Riley Purgatory Bluff Creek Watershed District Permit Application Review

Permit No: 2023-031

Project: Lake Susan Park Pond Reuse System Intake Modification – Modification of the existing pond water-reuse system and construction of a new intake structure and related piping and appurtenances.

**EXISTING CONDITIONS, REMOVALS, &
EROSION CONTROL PLAN**

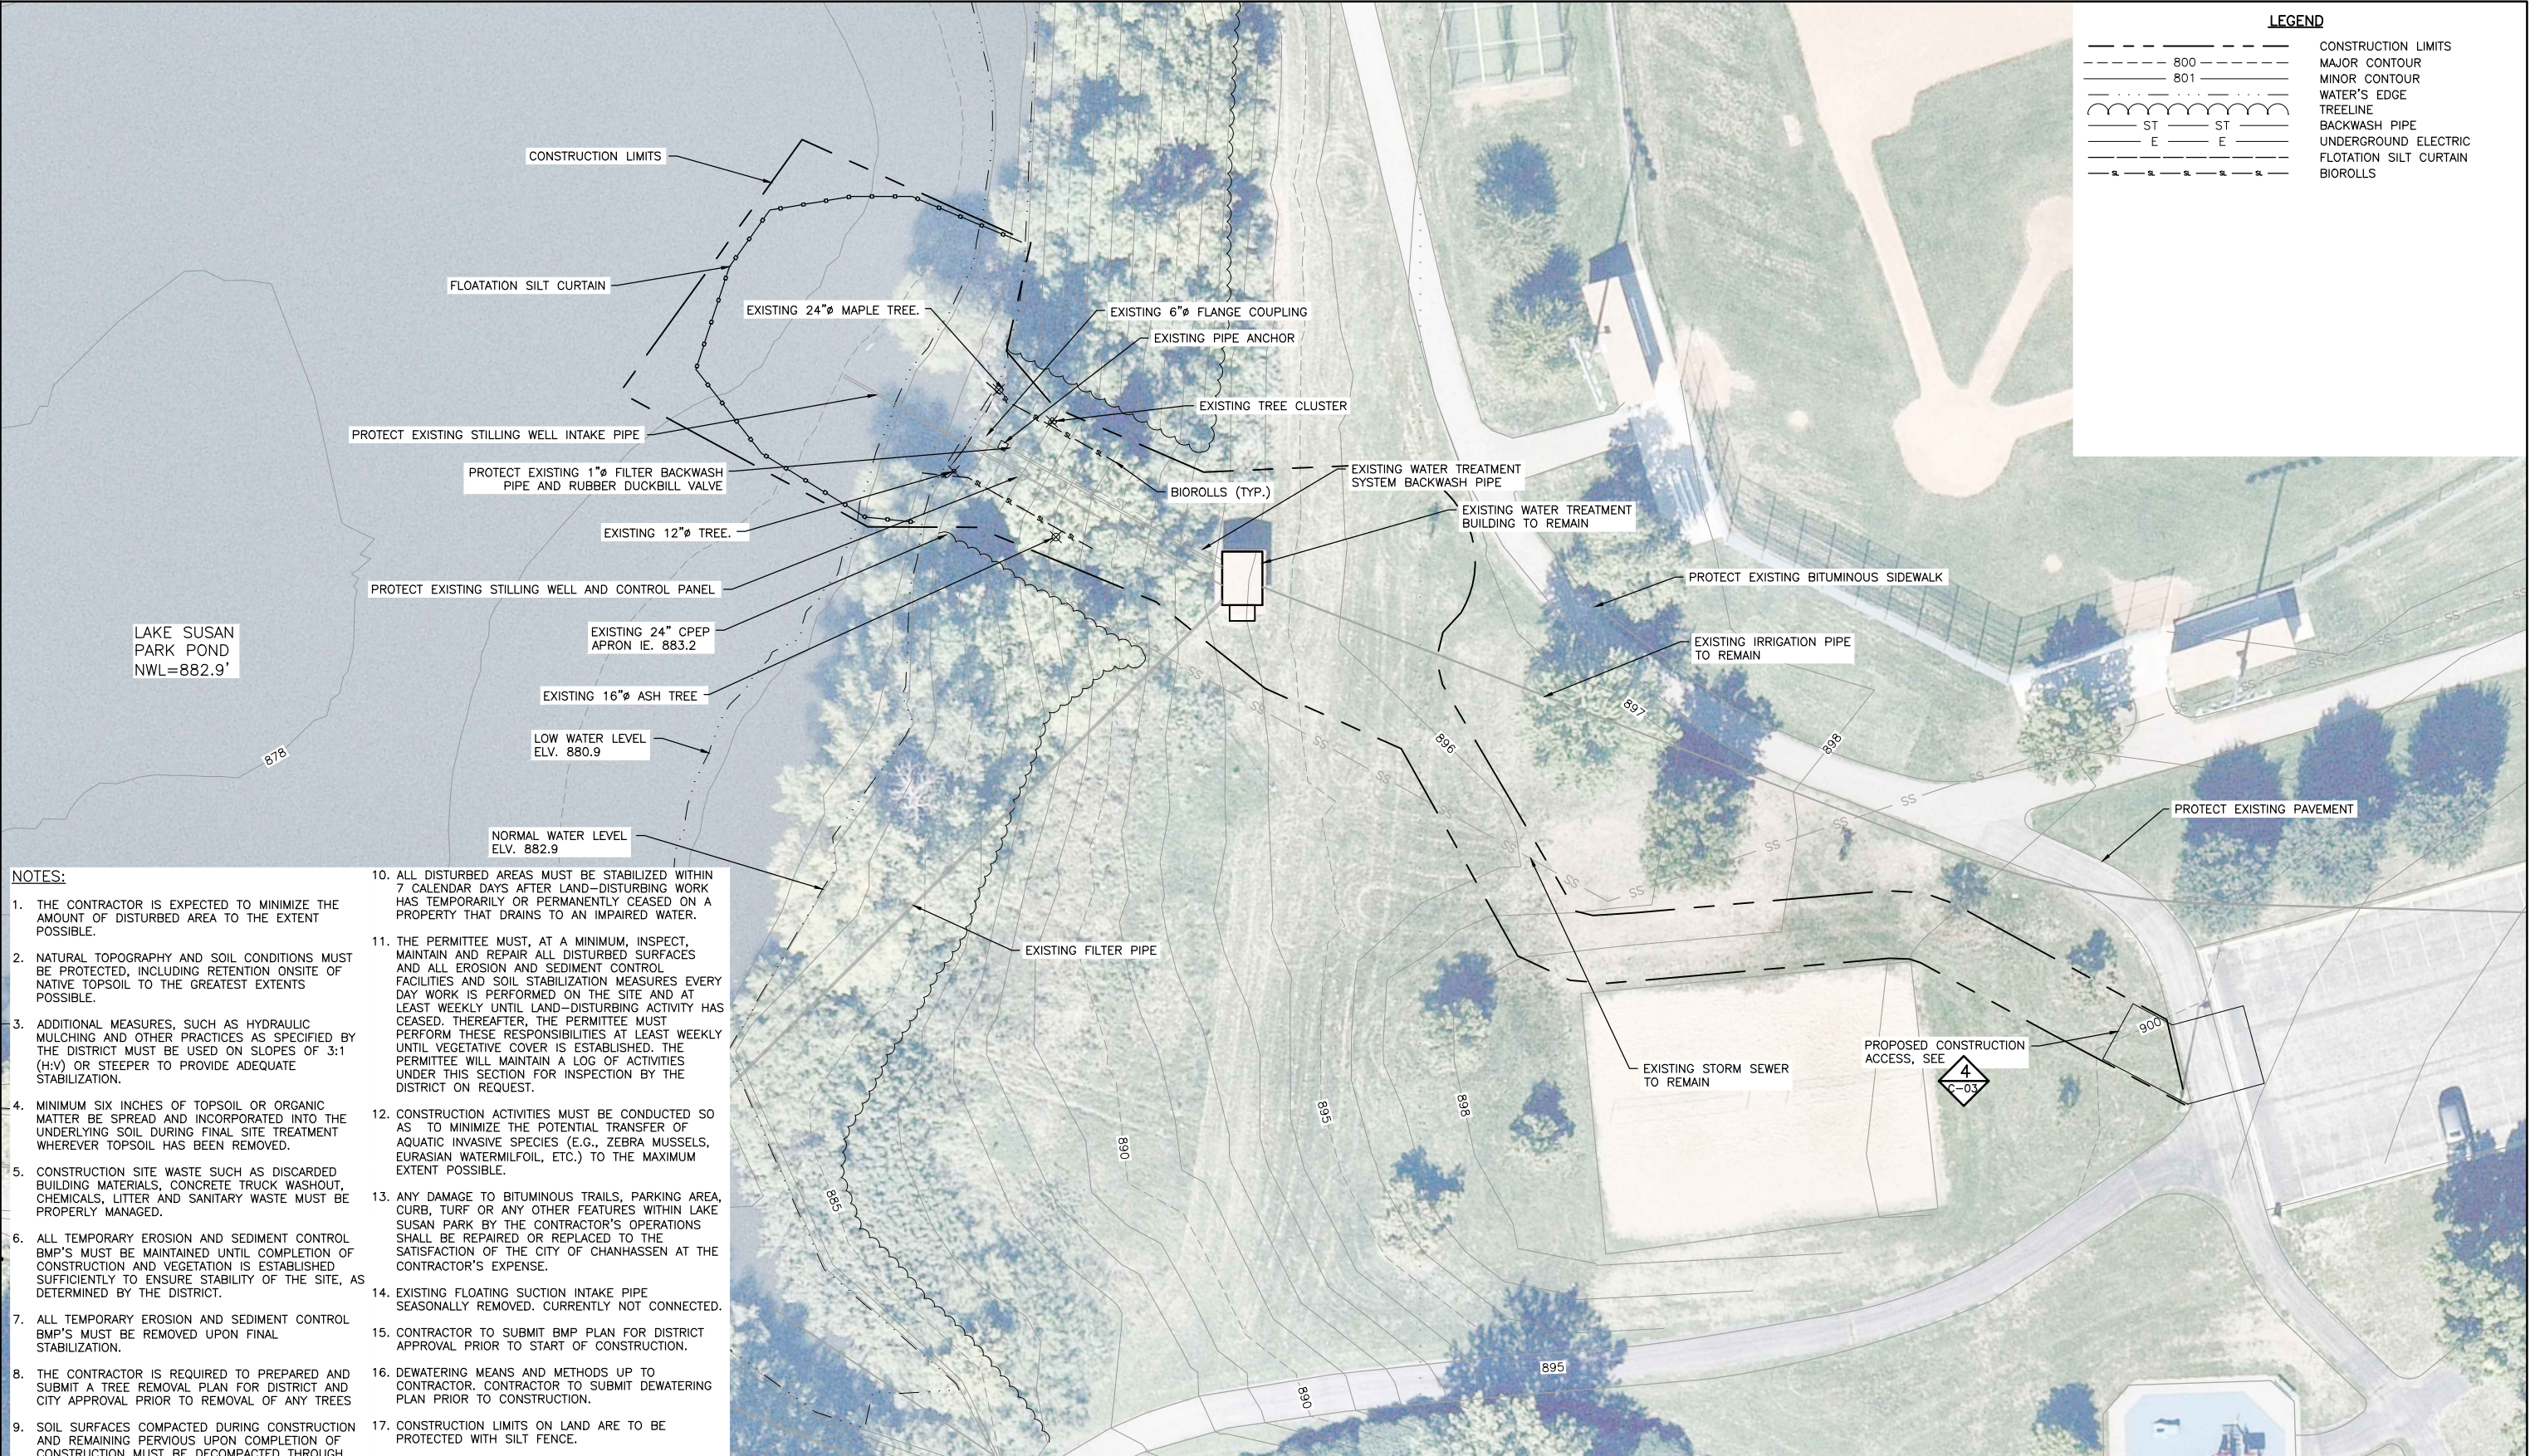
The erosion control/turf restoration plan includes installation of perimeter control measures such as biorolls, a construction access, floating silt curtain, turf establishment, daily inspection, placement of a minimum of 6 inches of topsoil, decompaction of areas compacted during construction, and retention of native topsoil onsite.

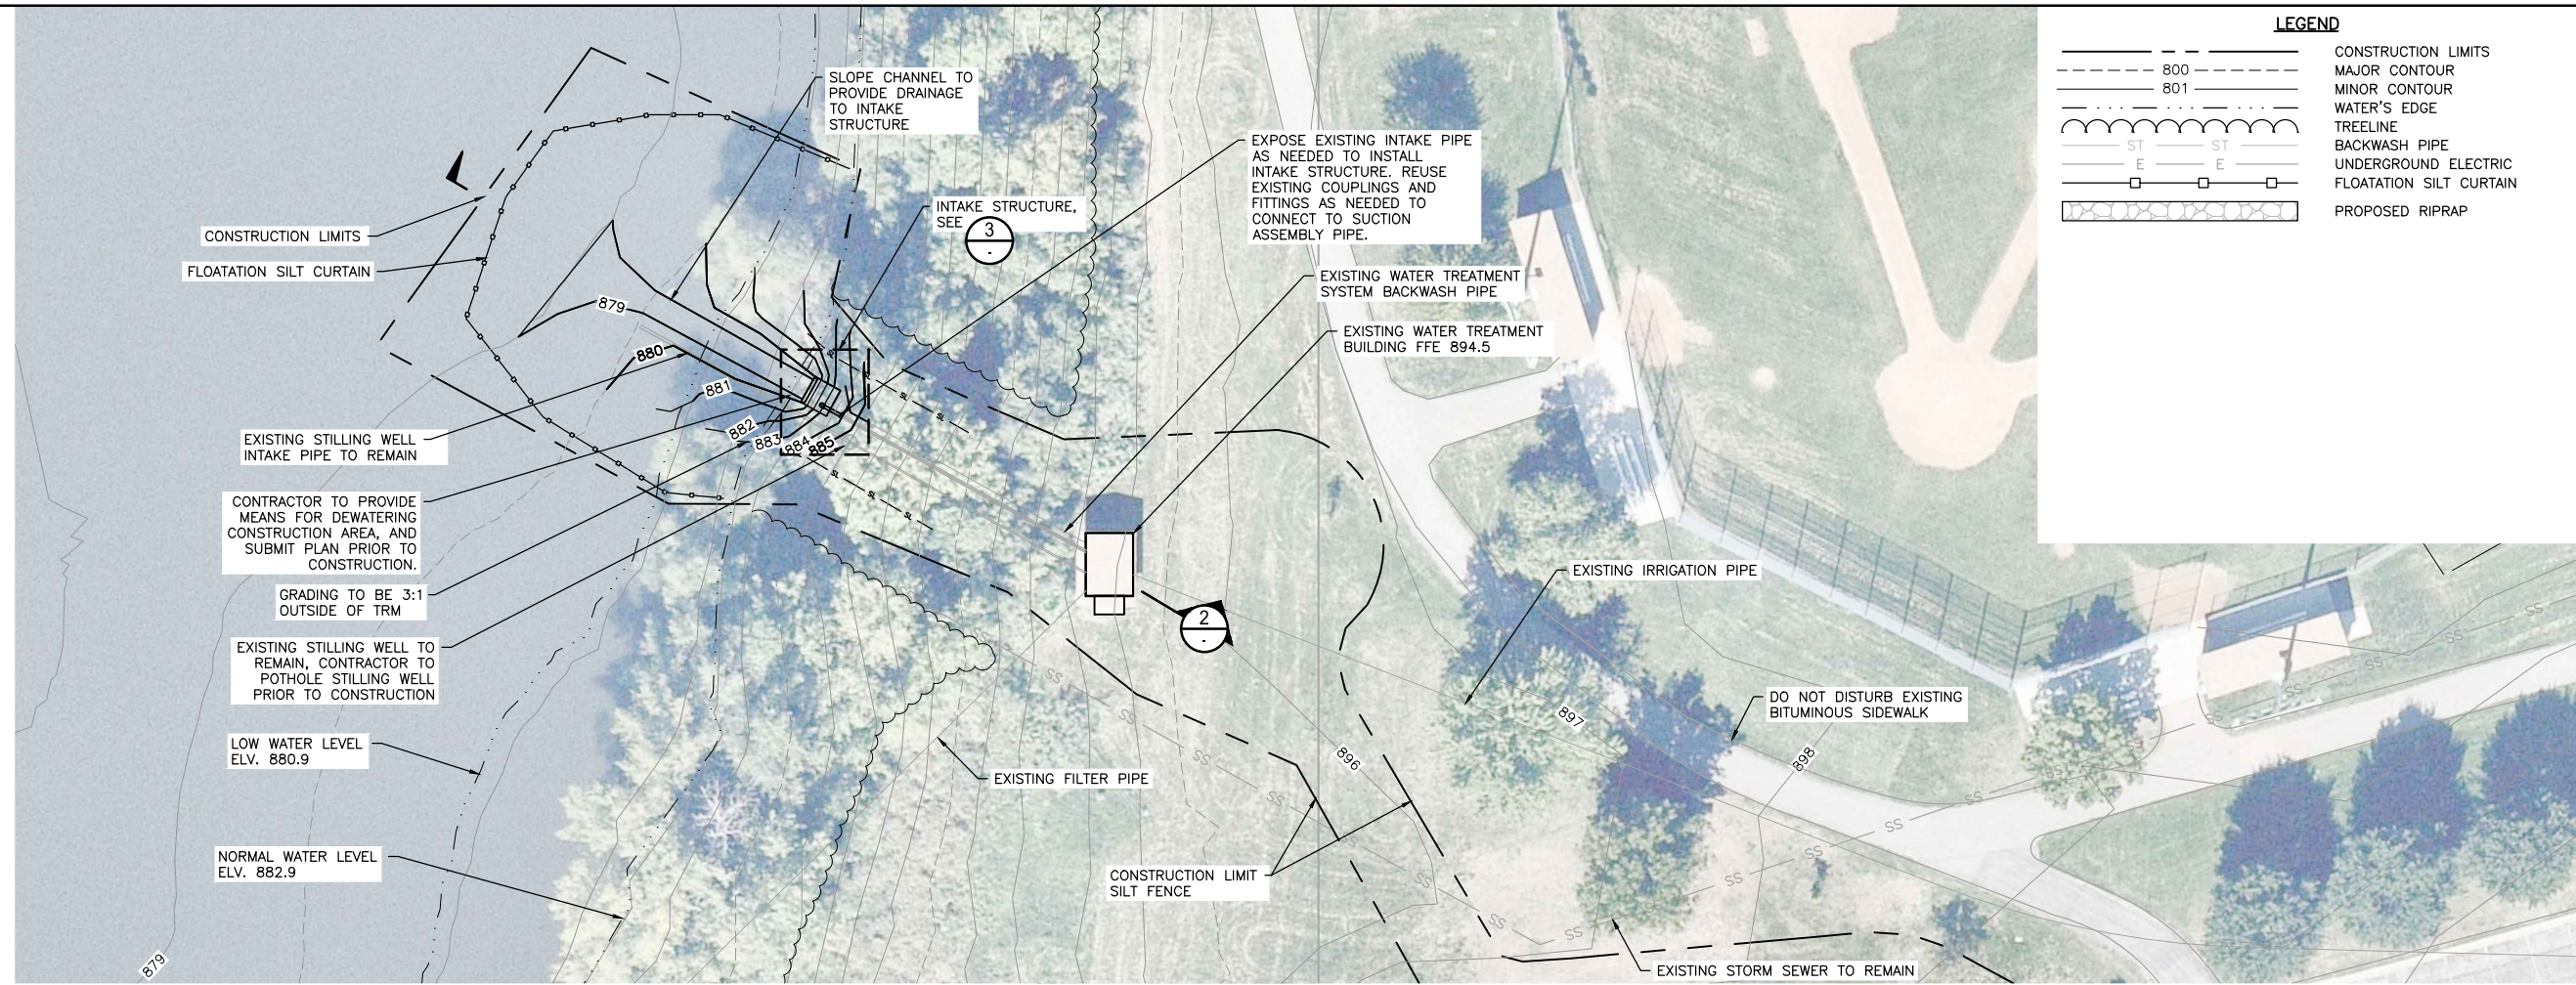
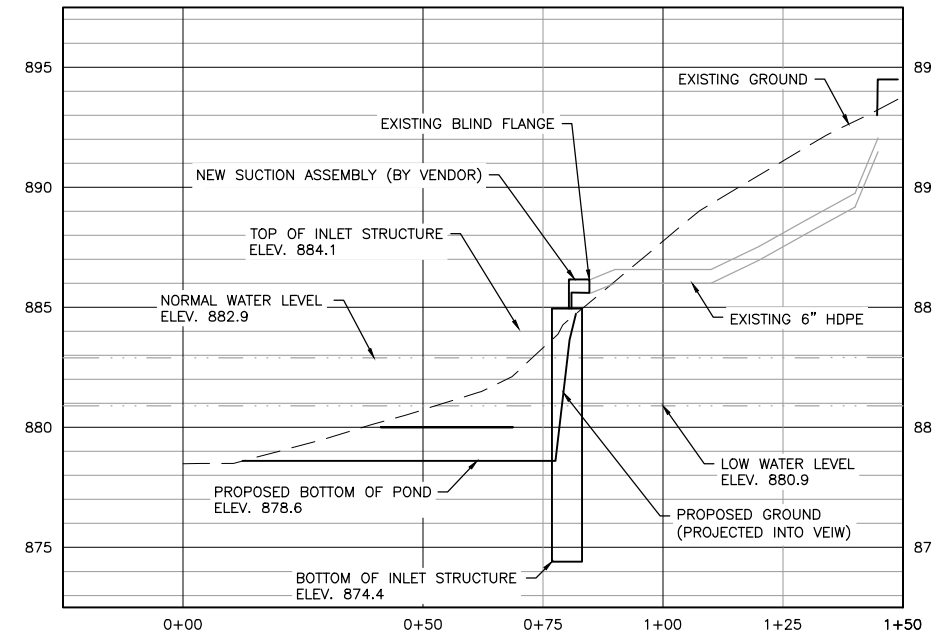
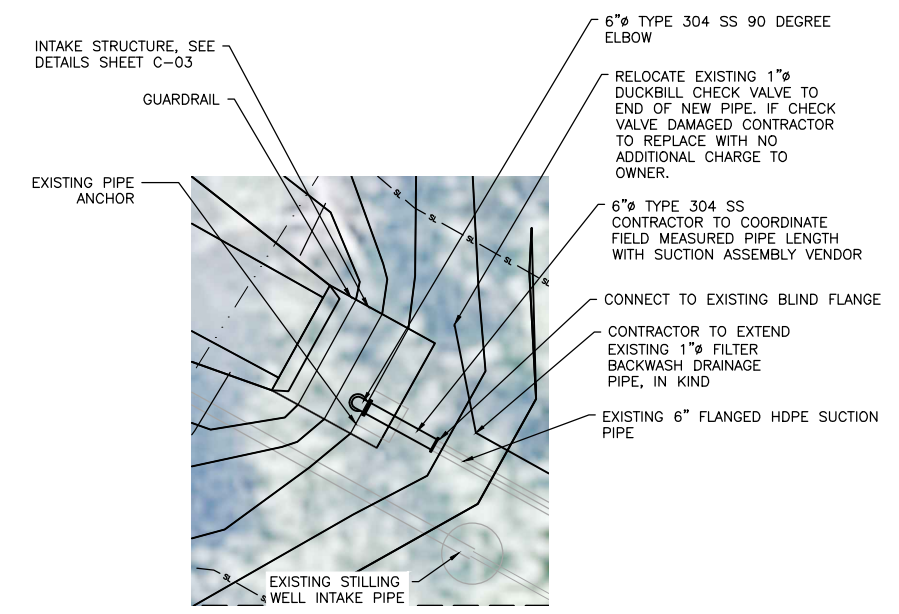
Because the grading plan illustrates that the 881 and 882 contours will be cut back into the existing grade (577 sf at elevation 881 and 138 sf at elevation 882) to produce an excavation or cut of about 357.5 cubic feet, the project results in a net increase in floodplain storage of 290.8 cubic feet. The supporting materials demonstrate, and RPBCWD staff concurs, that the project provides compensatory storage and conforms to Rule B, Subsection 3.2.
